SAFETY RECALL

Mack Trucks Inc.
Greensboro, NC USA

Date	Number	Release	Page
07.2024	SC0468	01	1(5)

Auxiliary Axle Tie Rod Assembly PN, GR, LR

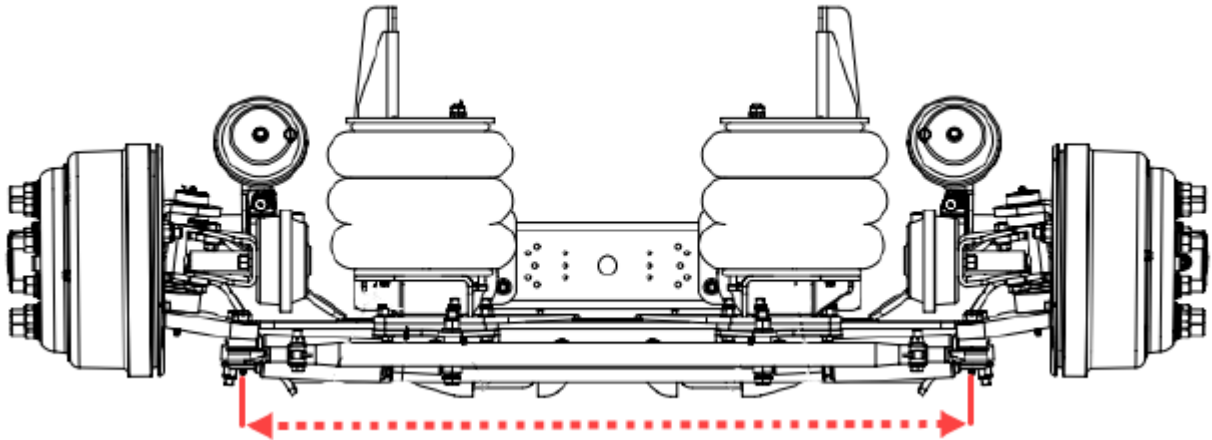
5. Hendrickson Compositite EXS20 lift axle suspension systems need to be inspected by looking for a stamped ID code on the tie rod. Please review the table below for the part numbers and date codes associated. If the tie rod does not have either of the suspect dates, return truck to service and file accordingly.

If ID code **101_24** or **130_24** is present, proceed with tie rod replacement.

6. Before disassembly, measure from the center of the tie rod zerk fitting on one side of the center of the zerk fitting on the opposite side. This will be the distance to set the new tie rod, once installed.

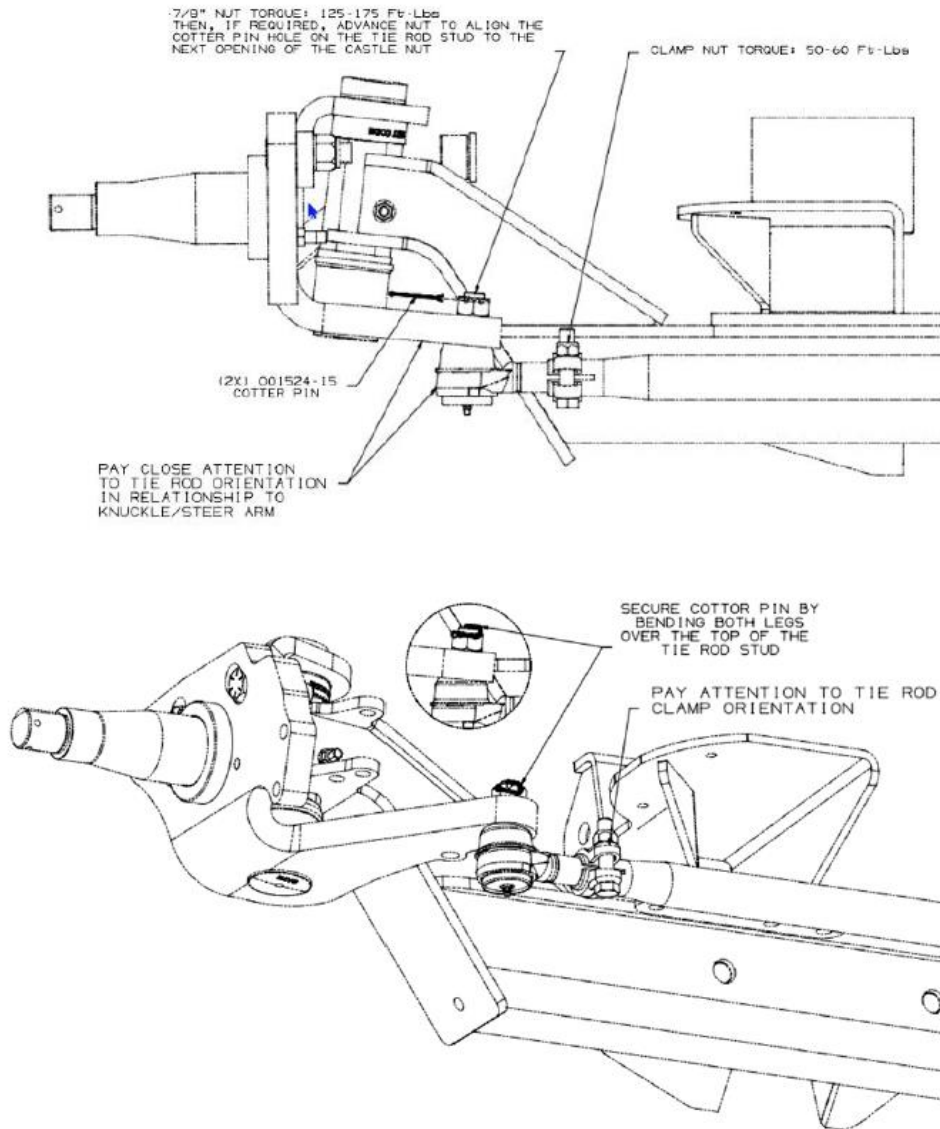
7. Secure the stabilizer position with ratchet straps.
8. Remove the cotter pins and castle nuts. Separate the tie rod from the knuckle assembly.
9. Install new tie rod and ensure castle nut is torqued to specification, ensure installation of the cotter pin is performed.
10. Drop the axle to the ground, unit unloaded. No air pressure in ride bags or under 10 PSI.
11. On both the front and back of tires, scribe the centerline of the tire. Using a trammel bar, measure the front and back of the tire and set toe in to $1/8$ to $1/4$ inch by rotating cross to achieve.
12. After the recommended toe in specification is achieved, tighten the tie rod clamp bolts to 40-60 lb-ft. Verify with a torque wrench.

13. Install the castle nuts. Please reference the figure below for torque specifications.
